SUBJECT: Forwards response to IE Bulletin 80-11, "Masonry Wall Design," supplementing response to NRC 820805 request for addl info. (

Re: St. Lucie Unit 1
Docket No. 50-335
IE Bulletin 80-11
Additional Information

ST LUCIE PLANT - UNIT 1
IE BULLETIN 80-11: MASONRY WALLS
NRC REQUEST FOR ADDITIONAL INFORMATION

WALL SECTION GH

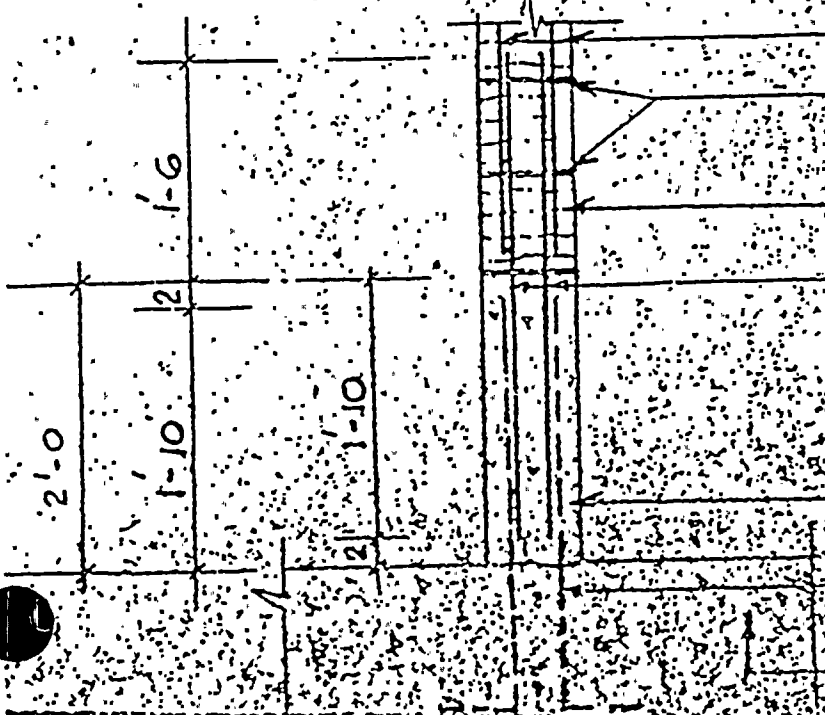
Indicate the number of walls of the stack bond type and provide a sample calculation to obtain moment and shear stresses of a typical stack bond wall.

The number of walls of the stack bond type is 65. A sample calculation of wall No. 34 that shows all analysis details is provided in Attachment A.

FINITE ELEMENT MODEL

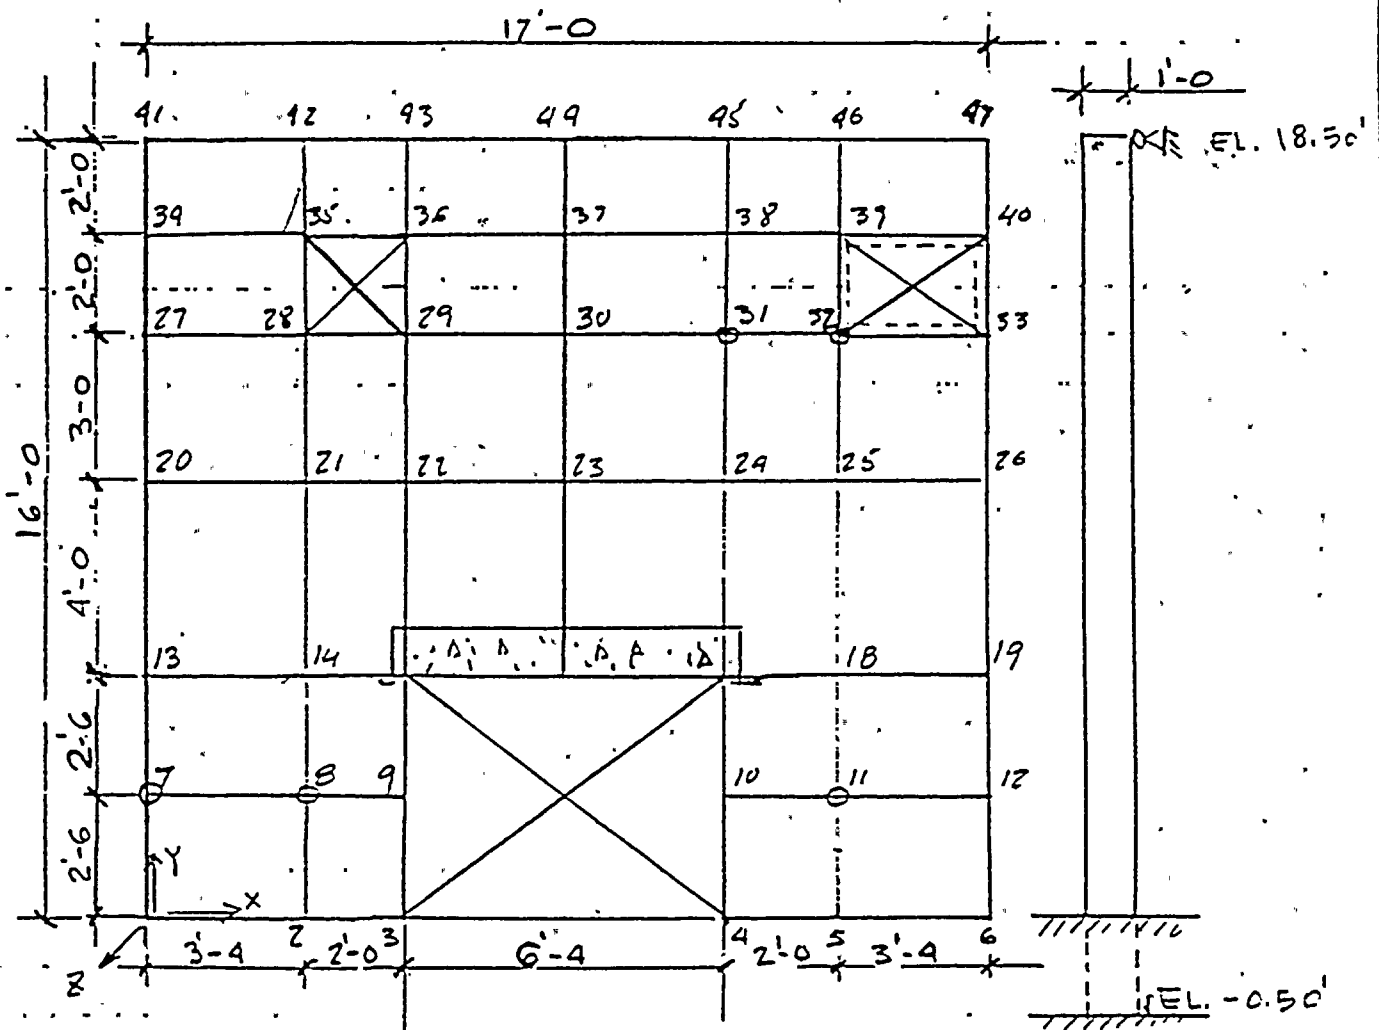
Provide a sample drawing of a finite element model to illustrate how openings and attachments were considered in the model.

A sample drawing of a finite element model to illustrate how openings and attachments were considered in the model is provided in Attachment A.

THE WALL SIMULATED BY THE FINITE ELEMENT MODEL AS SHOWN IN SKETCH.
